SERVICE BULLETIN #121

1/23/14

4023 Aluminum Disc Wheel Hub

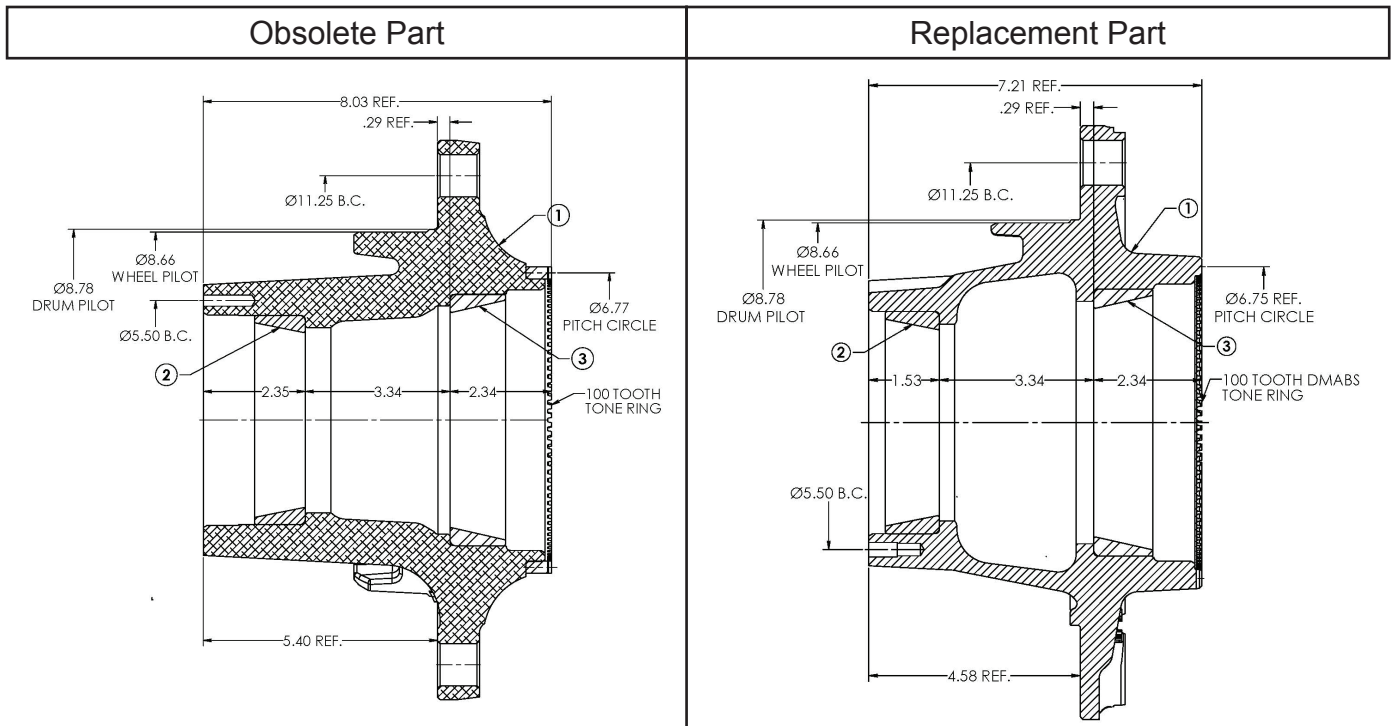
The 4023 Aluminum Disc Wheel Hub is obsolete with no direct replacement. We do, however, recommend a replacement: the 10-stud 2023 Ductile Iron Disc Wheel Hub. There are no other component changes required for this interchange. The same assembly options are available for the 2023 Disc Wheel Hub as were previously offered with the 4023 Disc Wheel Hub. If you have any questions, please contact the Webb Wheel Engineering Department via email to engineering@webbwheel.com or call 256-736-6356.
